MAINE TURNPIKE AUTHORITY

ADDENDUM NO. 1

CONTRACT 2018.12

**Pavement Rehabilitation, Guardrail,
Drainage, and Clear Zone Improvements
MM 74.9 to MM 80.7**

ESTIMATED QUANTITIES AND GENERAL NOTES

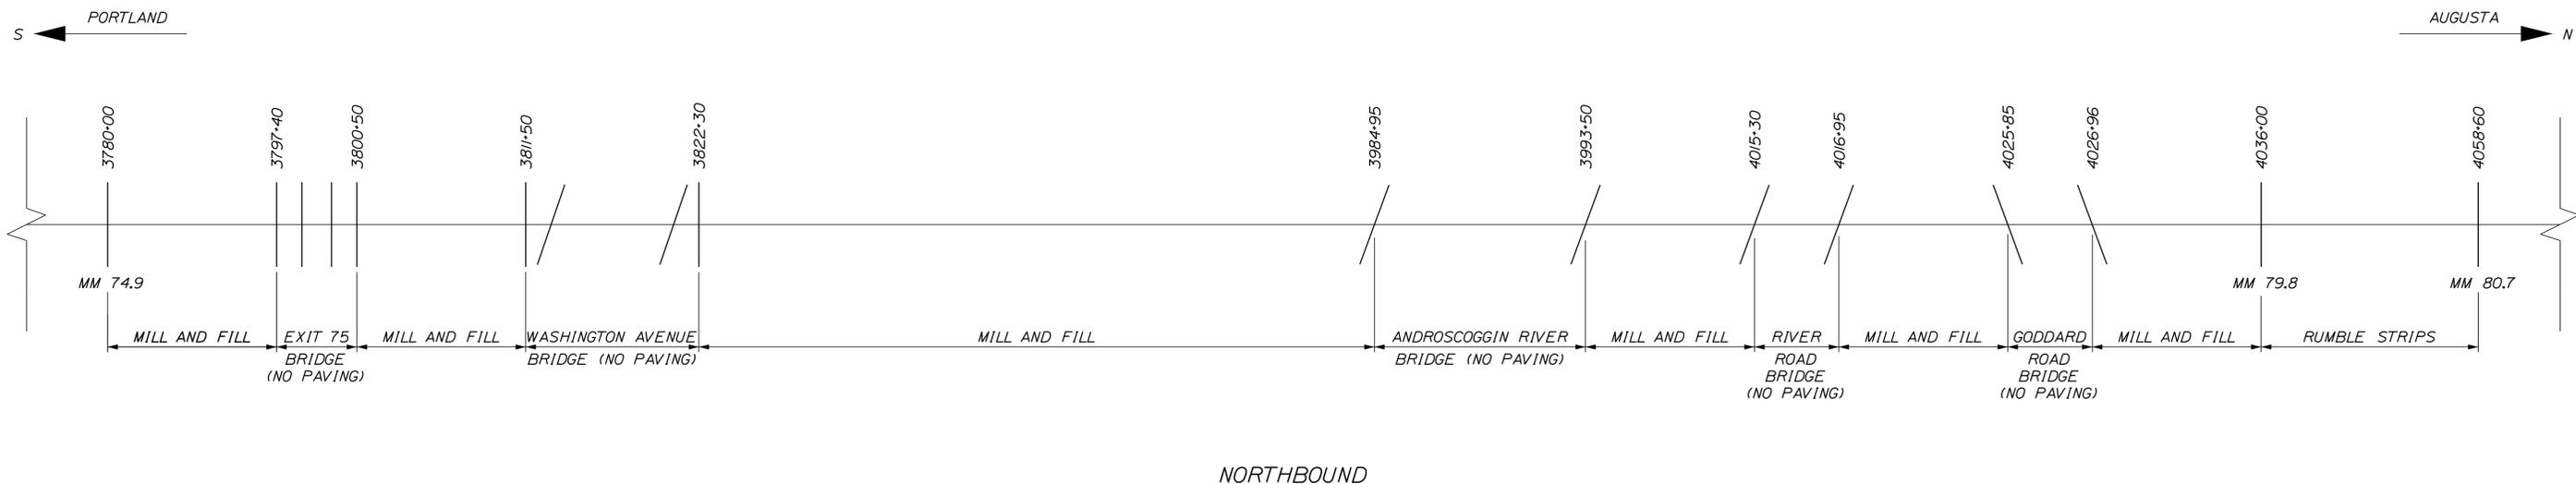
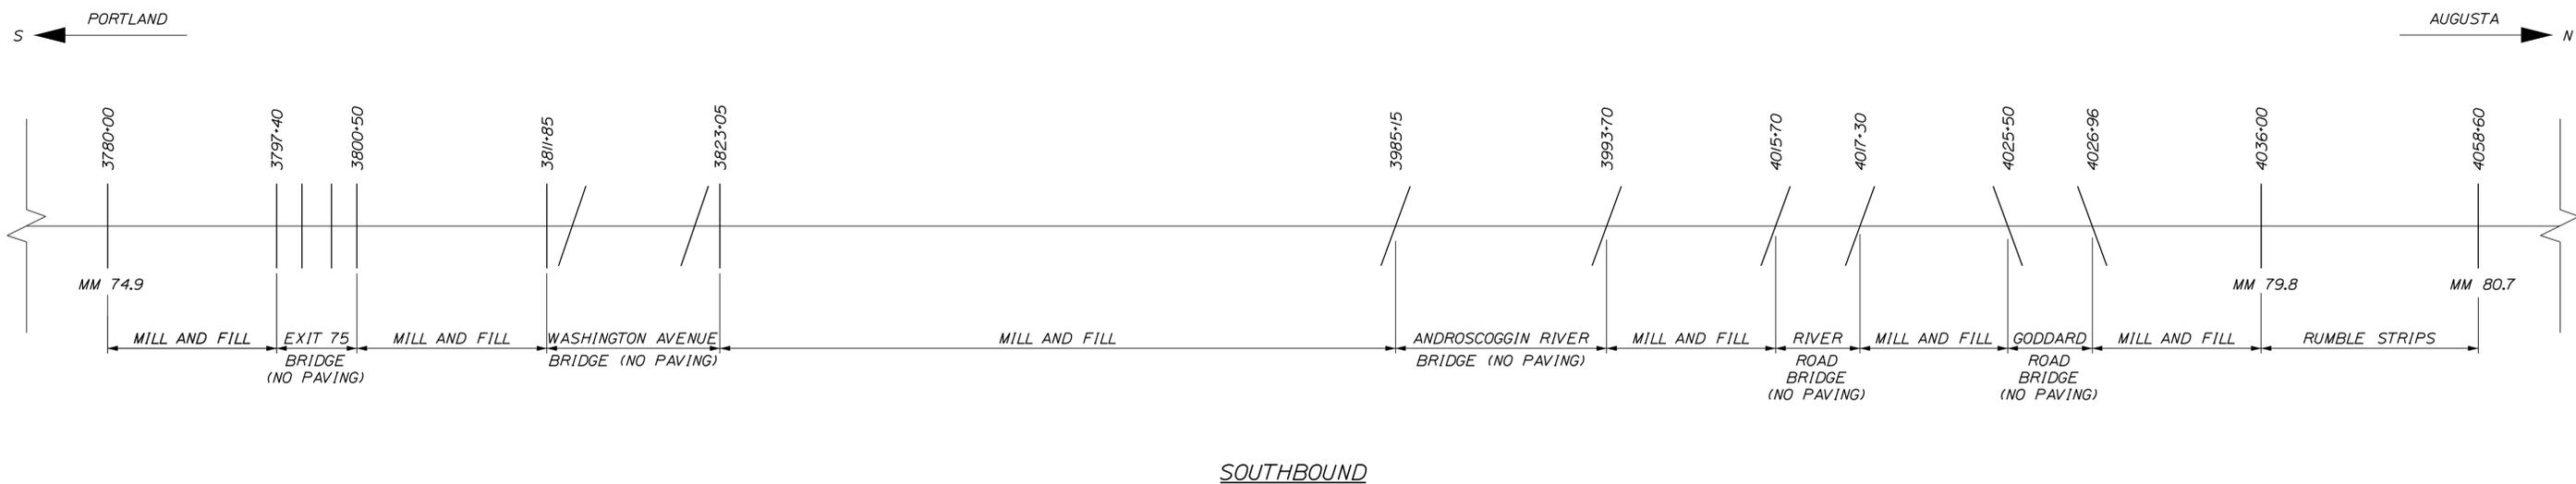
Plan Sheet 2 of 27, “Estimated Quantities” is deleted and replaced in its entirety with the attached revised sheet 2.

No.	Revision	By	Date
1	UPDATED QUANTITIES	JRH	4/10/2018
